CITY OF ALBUQUERQUE

RE: **Lot 15 Block 6 SAD 227**
Unser Cliffs
8023 Victoria NW
Grading and Drainage Plan
Engineers Stamp Date 10/16/17 (D10D040)

Based upon the information provided in your submittal received 10/17/17, this plan cannot be approved for Grading Permit until the following comments are addressed.

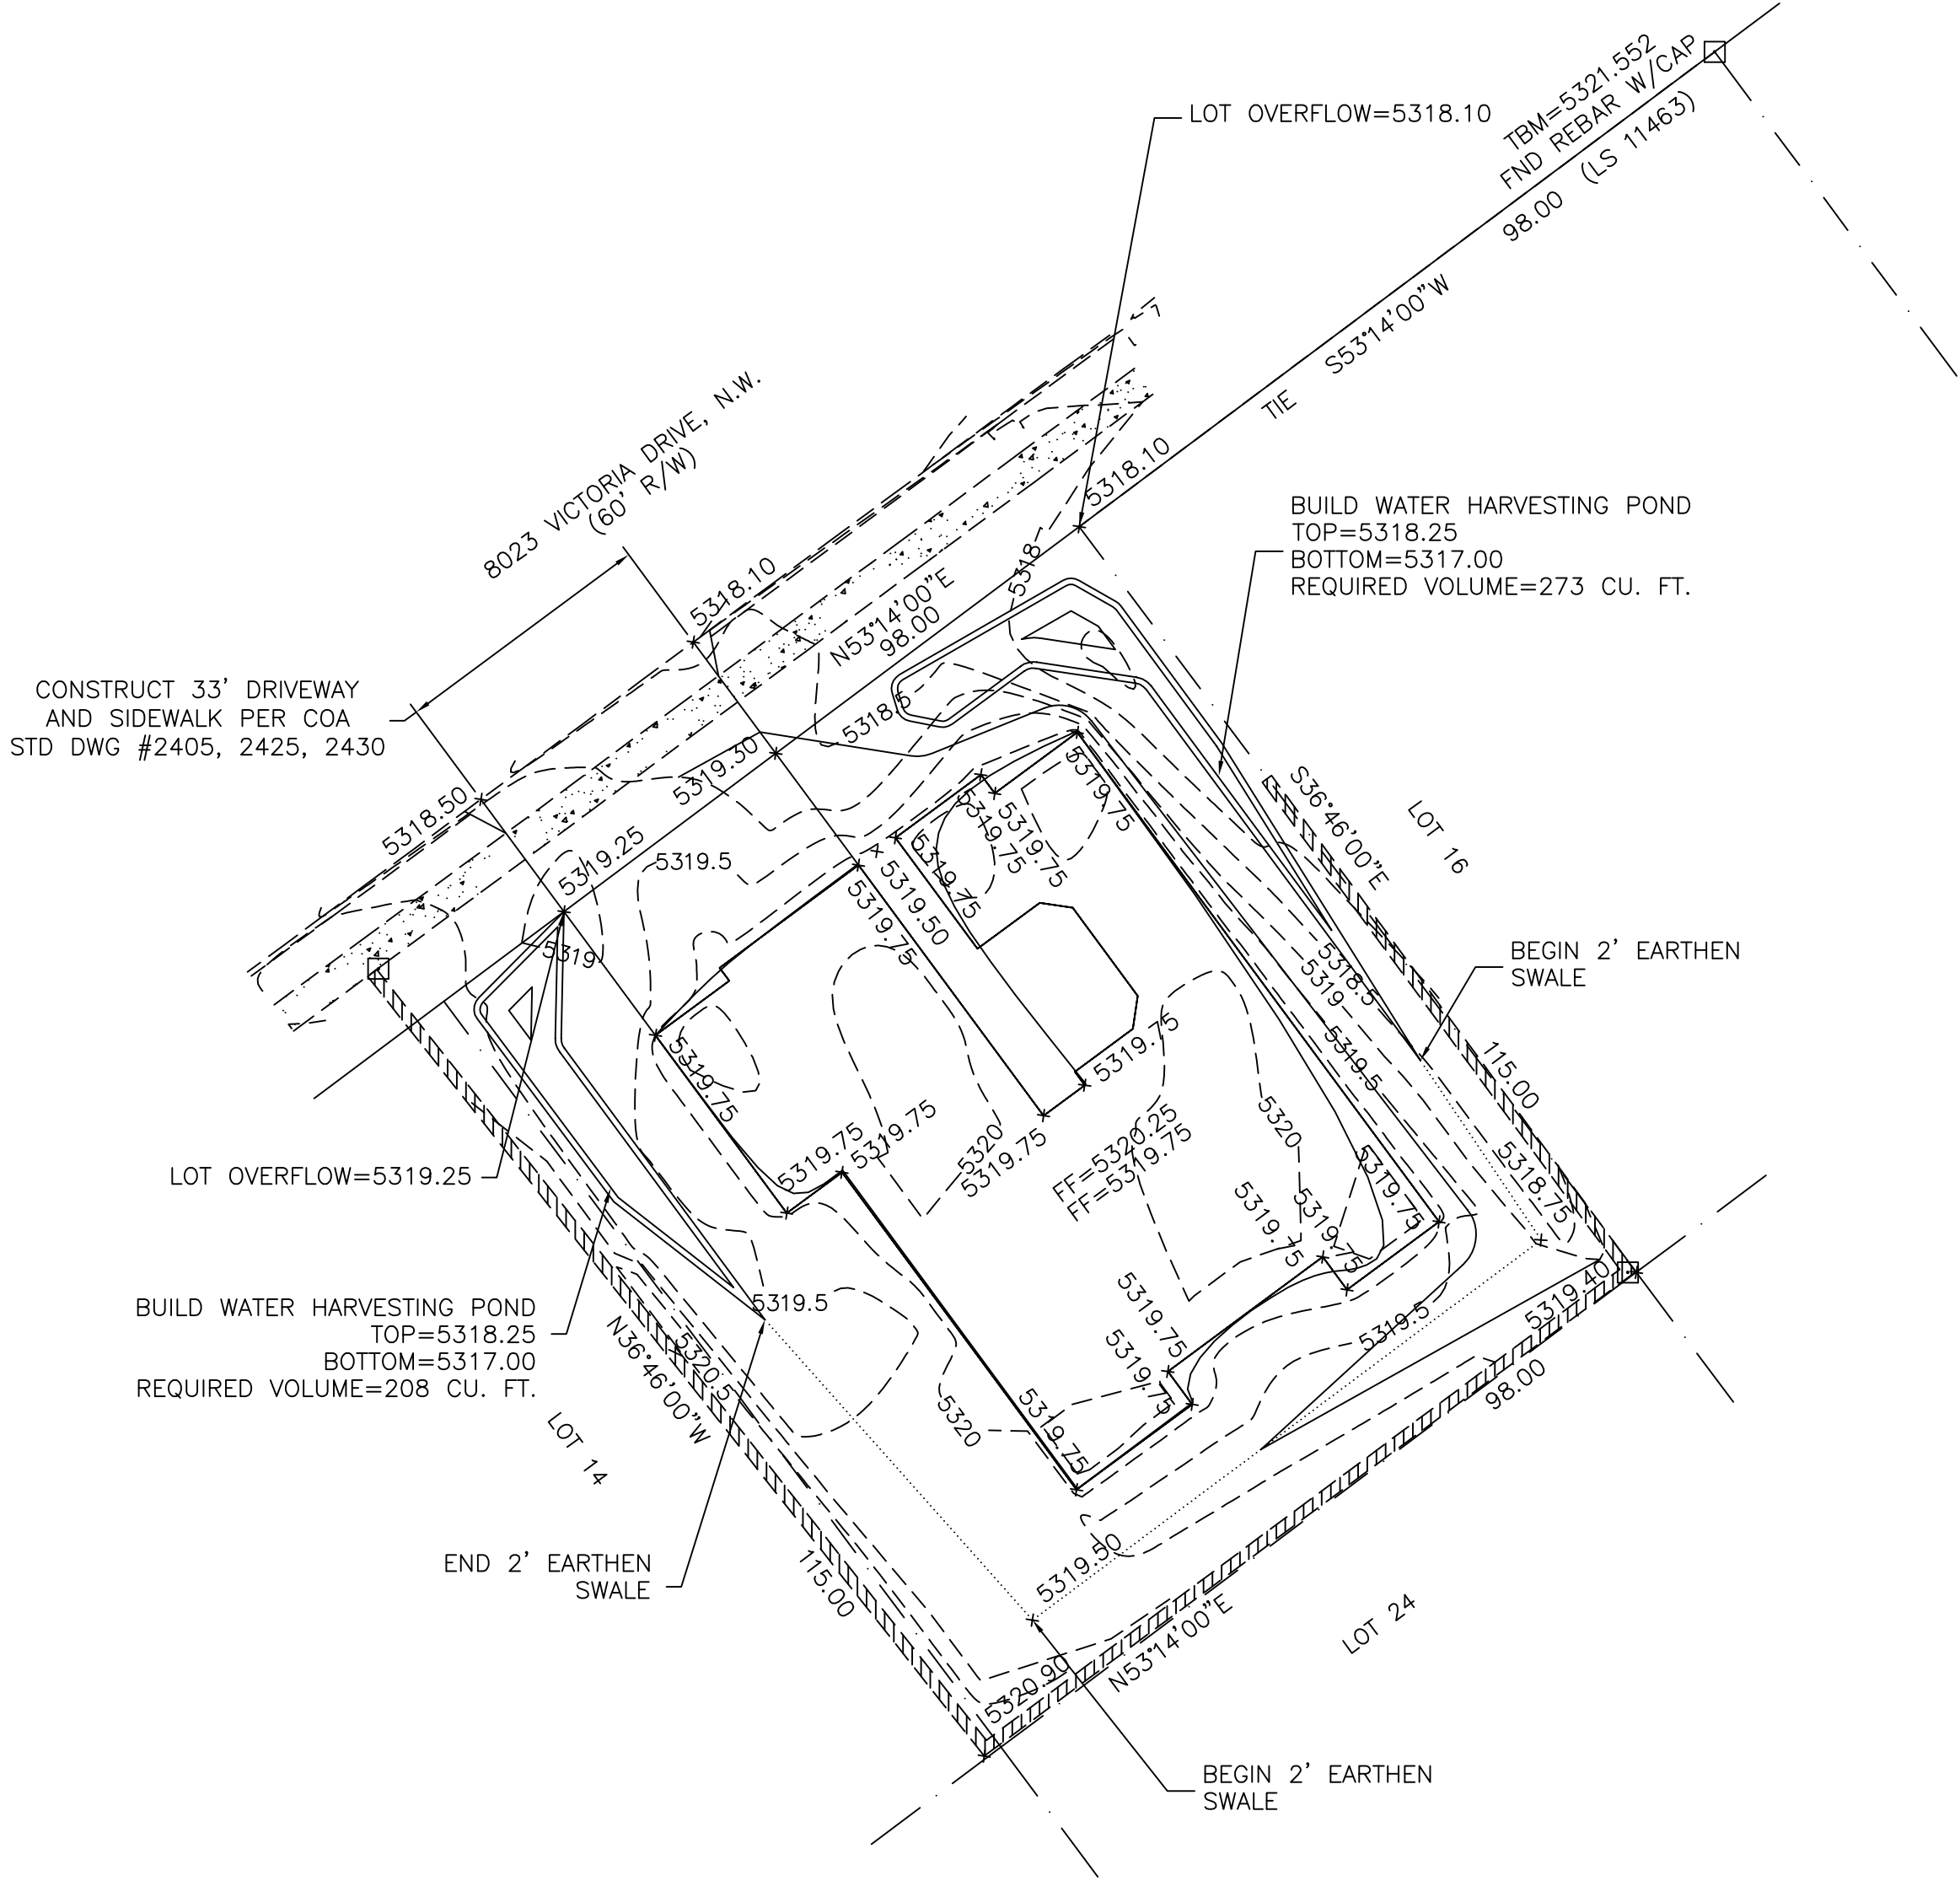
- Provide a statement on the plan stating that this grading plan must be submitted for the application of any garden/retaining walls.

Prior to Certificate of Occupancy release, Engineer Certification per the DPM checklist of this plan will be required.
